re: Geotechnical Review – Grading and Landscaping Plans
Proposed Residential Development
475 Terry Fox Drive – Ottawa, Ontario

file: PG7418-MEMO.02 Revision 4

Figure 1 – Recommended Lightweight Fill Location Plan

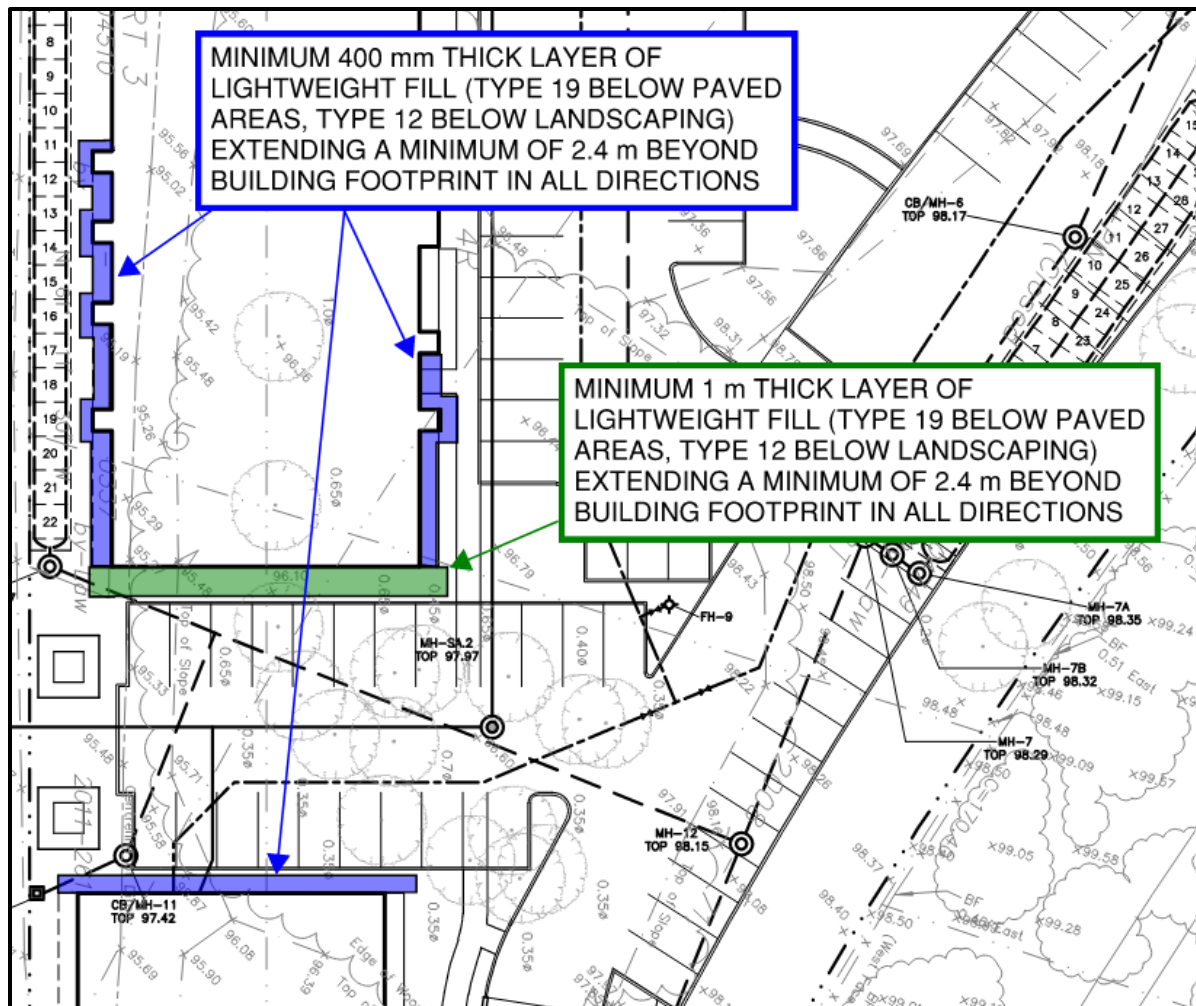
However, some grade raise exceedances were identified in areas surrounding the proposed Building B and Building C. For these areas, lightweight fill is recommended to be placed per the locations identified in Figure 1 below to accommodate the grade raise restriction exceedances and mitigate long-term settlements.

Lightweight fill (LWF) should consist of EPS (expanded polystyrene) Type 19 and Type 12 geofoam blocks throughout hardscaped (paved or other areas with concrete surface features) and landscaped areas, respectively. The LWF is recommended to be placed a minimum of 500 mm above any perimeter drainage sleeves/pipes provided to the main building structures foundation and the associated open-graded stone layers. The lightweight fill should be placed upon a flat soil surface. Therefore, the soil should be compacted to be relatively smooth and flat prior to installation. Consideration may be given to placing a thin layer of sand or stone dust to attain a relatively smooth/flat surface for placement.

The entire lightweight fill layer footprint is recommended to be covered with a layer of polyethylene (taped at seams) extending between the building footprint and outer edge of the layer and extending below its surface by a minimum of 100 mm at all edges of the lightweight fill layer.

If the lightweight fill will be located in an area of landscaping, a minimum 600 mm of soil cover is recommended to be provided to the lightweight fill layer to promote grass and associated vegetation to establish overtop the lightweight fill. The placement of all lightweight fill should be reviewed at the time of placement by Paterson personnel. It is advised that a brief pre-construction meeting be held between Paterson and the construction team to confirm placement methodology prior to the installation.
